County of Fairfax, Virginia

Re: Interpretation for SE 2008-DR-003, Chevy Chase Bank Tax Map 30-2 ((5)) 6, 9, and 10: Signage

RE: Request for Interpretation
SE 2008-DR-003
Chevy Chase Bank (now Capital One Bank), Dolley Madison Boulevard

Capital One Bank – Proposed Sign Rendering

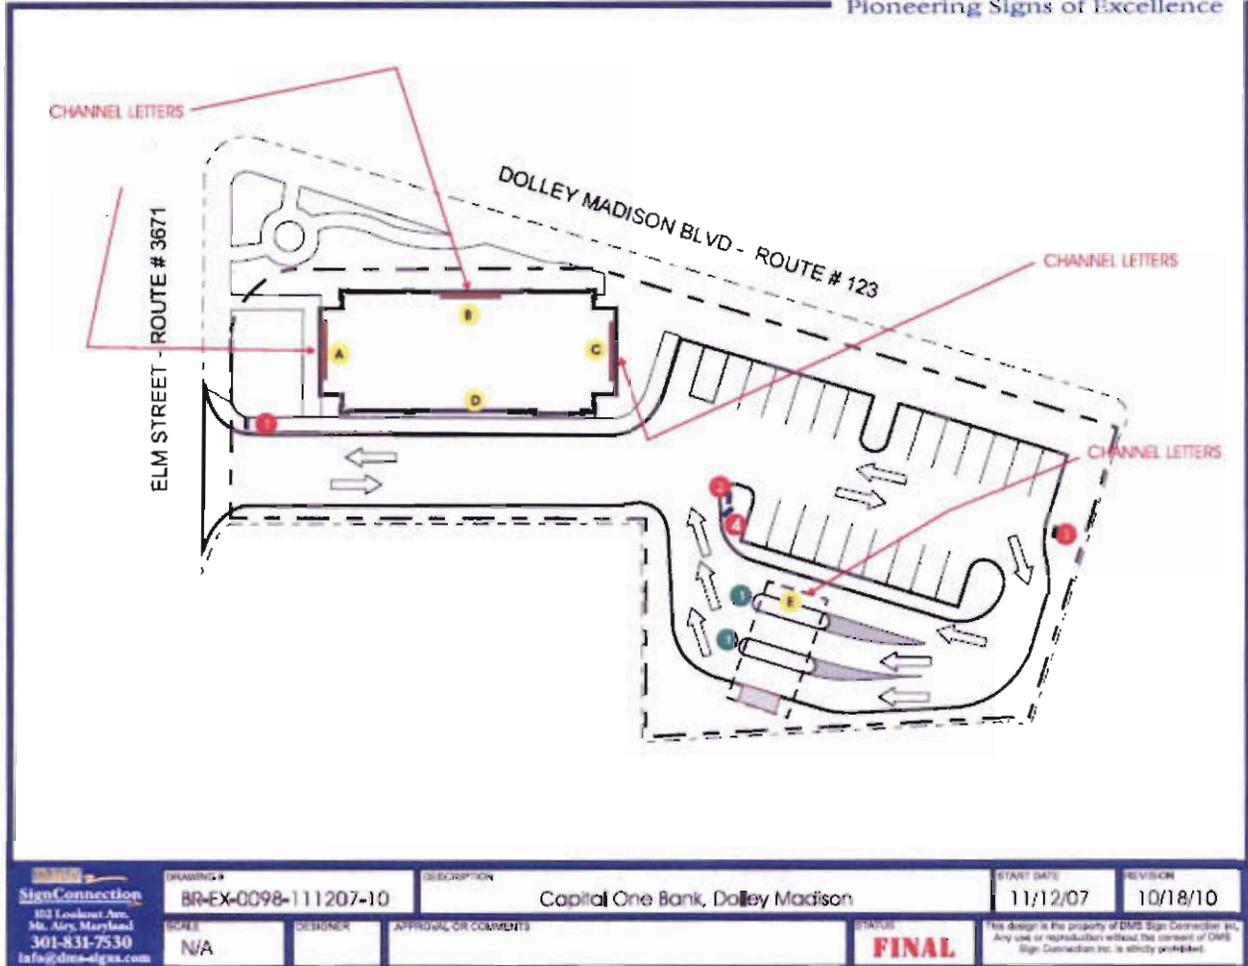
You indicate that Capital One Bank now proposes to install a 15 SF internally illuminated sign on the northern facade of the remote ATM drive-through structure located on the site. You state that you would be utilizing 105 SF of sign area on the main bank building (3 sides x 35 SF), and 15 SF on the ATM drive-through structure for a total of 120 SF, which is within the 124 SF of sign area approved in the Special Exception. You also state that the sign would be of the same construction as the three building signs and that it would be unlit from 9:00 pm to 7:00 am daily. According to the photographs submitted, additional sign area is also proposed above each of the two ATM facilities on the building and the outside of the remote ATM structure.

As a result of this interpretation it is our intention to apply for a permit to install an internally illuminated Capital One Bank sign on the northern facade of the ATM drive thru structure, to be unlit from 9:00 pm to 7:00 am daily. This sign would be of the same construction as the (3) approved building signs; however, it would be only 15 SF. With this sign installed, we would be utilizing 105 SF on the main building (3 x 35), and 15 SF on the ATM drive thru structure for a total of 120 SF. This would be within the 124 SF approved in the Special Exception. Since Development Condition #6 does not specifically deny or approve this sign, we thought it best to seek a formal interpretation from you regarding this condition.

The proposed sign on the remote ATM structure could be considered in substantial conformance with the SE Plat and development conditions, provided that the total allowable sign area (124 square feet) is not exceeded, and provided that the design (individual letters) and color (internally lit red plastic) specifications of the Development Condition 6 are met. However, based upon the submitted photographs and graphics, the design and color specifications are not met for the existing signs, and, based upon a site inspection by Zoning Enforcement, the sign area utilized for the two signs above the ATMs would not leave sufficient sign area remaining for the proposed additional sign on the ATM structure. Therefore it is my determination that the proposed addition of a sign on the remote ATM structure would not be in substantial conformance with the SE Plat and development conditions. In order to allow the proposed sign, and the design and color of the existing signs illustrated, the submission of an amendment to SE 2008-DR-003 and its approval by the Board of Supervisors would be required.
